SERVICE BULLETIN

MITSUBISHI MOTORS

PURPOSE : CHANGE	ISSUE NO. : MSB-15EXL54-001	DATE : 2015-02-18
SUBJECT : Changes and addition of the descriptions about o-ring		<DESTINATION/MODEL> <M/Y> (As per attached sheet 1) 14-14.5
GROUP : Gr:54(Chassis electrical)		Outlander PHEV(GG0W)

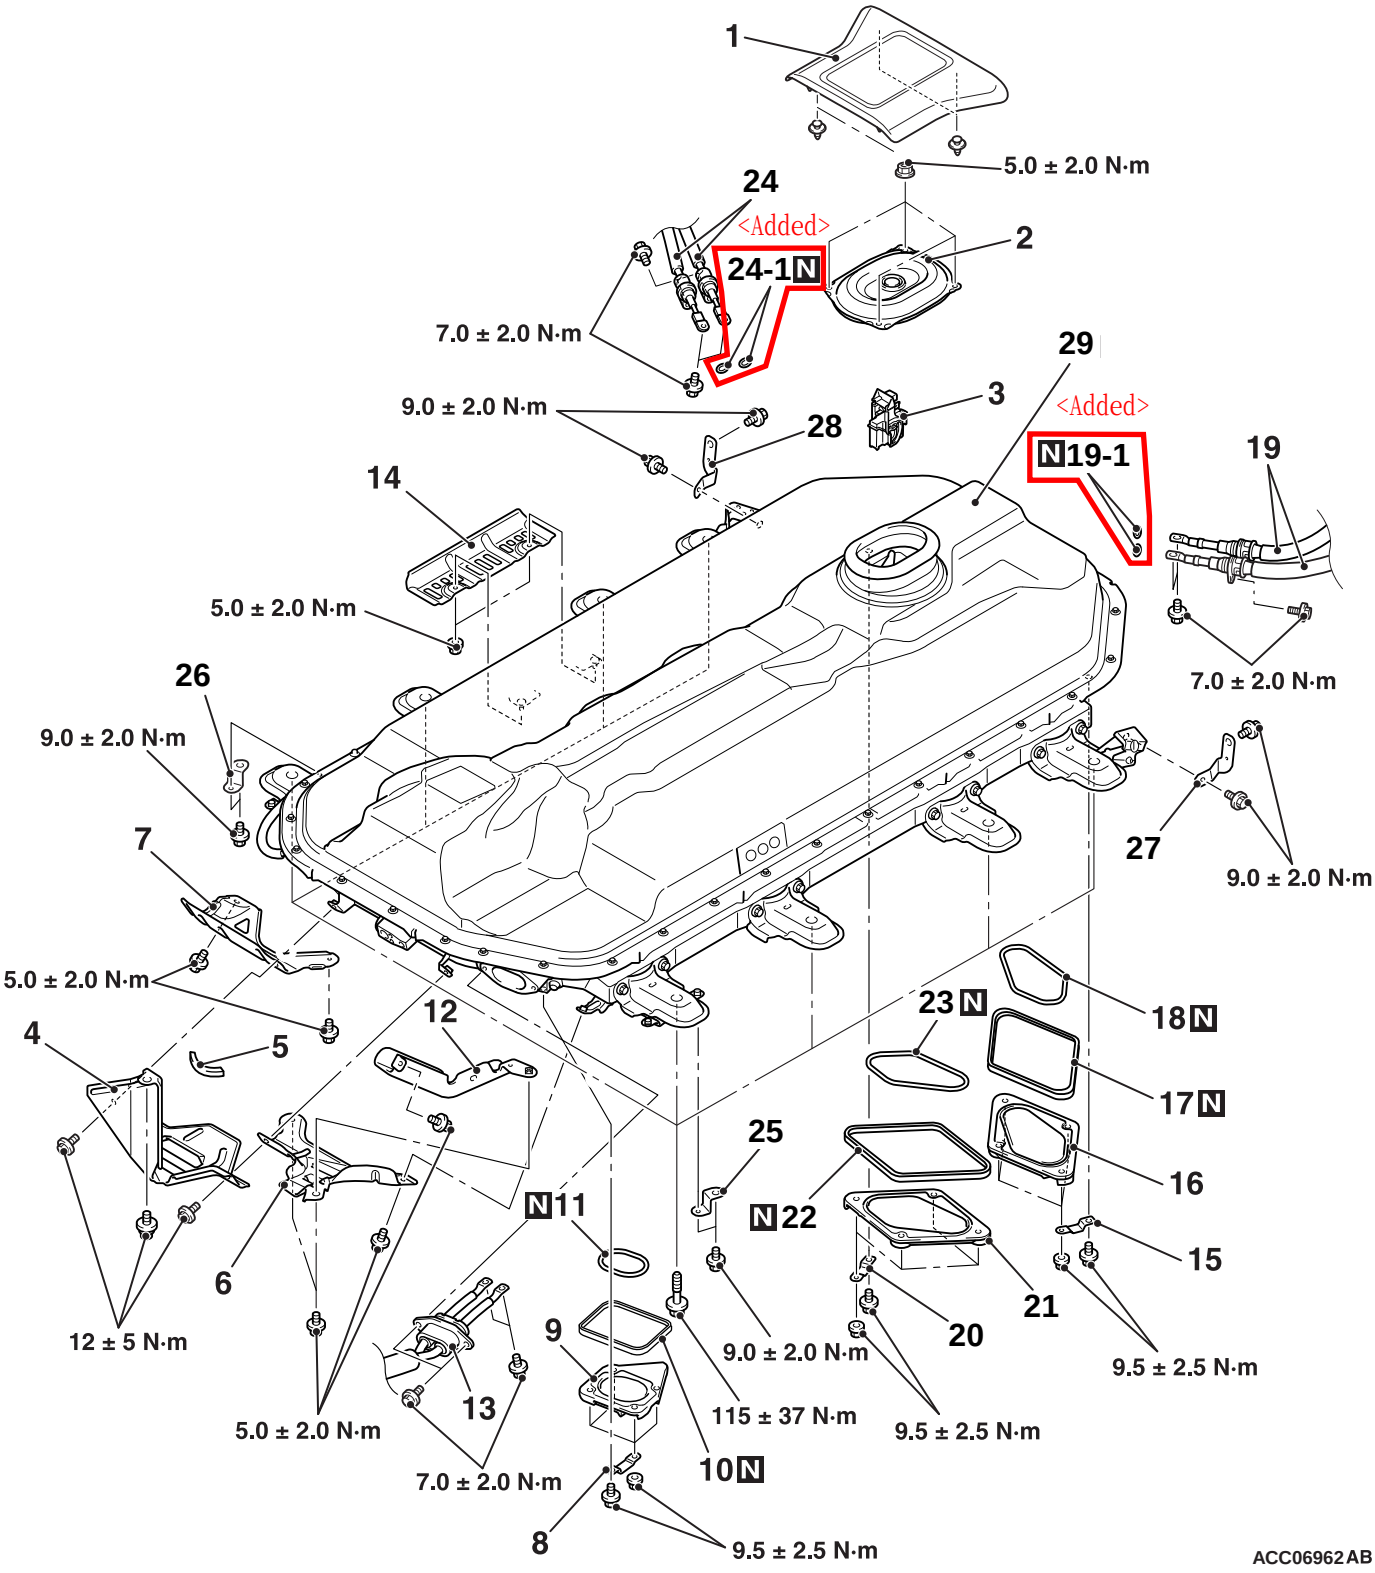
<Deleted>

LUBRICANT

Item	Specified lubricant	Quantity	Remark
O-ring (for the traction battery cable)	NIGLUBE RM or equivalent	As required	Brake grease

12. Cable protector
<<B>>	>>F<<	13. drive battery front cable (P, N line) connection
		14. Battery side protector
	>>D<<	15. Battery earth bracket
		16. Work-hole lid <rear>
	>>C<<	17. Work-hole lid pad <rear>
		18. O-ring
<<C>>	>>E<<	19. Drive battery rear cable (P, N line) connection
	<Added>	19-1. O-ring
	>>D<<	20. Battery earth bracket
		21. Work-hole lid <rear> <Vehicle compatible with quick charging>
	>>C<<	22. Work-hole lid pad <rear> <Vehicle compatible with quick charging>
		23. O ring <Vehicle compatible with quick charging>
<<D>>	>>B<<	24. EV charger cable (Quick charging P, N line) connection <Vehicle compatible with quick charging>
	<Added>	24-1. O ring <Vehicle compatible with quick charging>
		25. Battery earth bracket
		26. Battery earth bracket
		27. Battery earth bracket <LH>
		28. Battery earth bracket <RH>
<<E>>	>>A<<	29. Drive battery assembly
